Design Review Board Case # 20-0002
Block 32 – Carlyle Plaza II / Carlyle Park Towers

Block 32 – DRB Concept Review

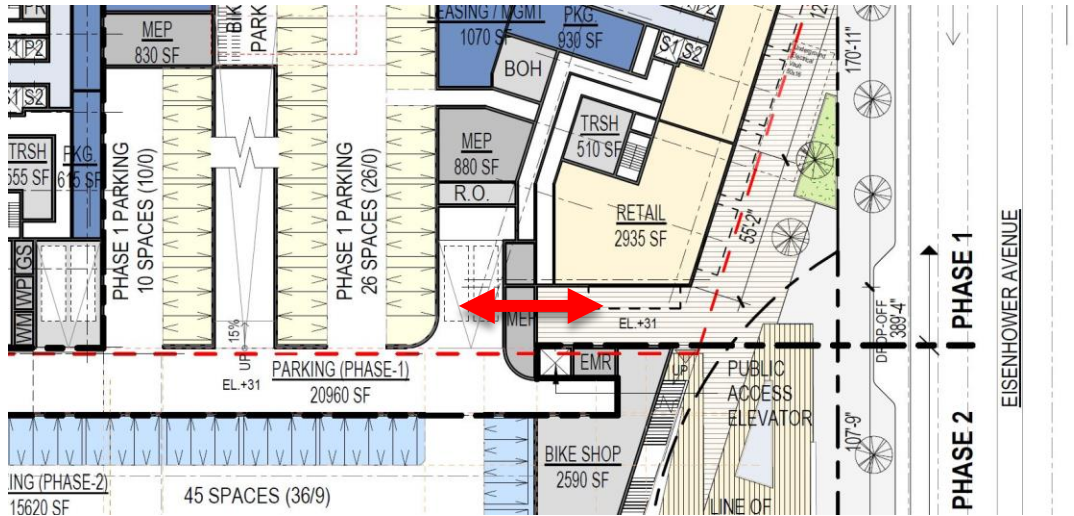
- Provide the gross floor area and net floor area for Phase 1 on page 2 “Zoning Tabulation”.
- Provide enhanced, direct access from ground floor level of the parking garage to the ground floor plaza for improved retail access. See diagram below.
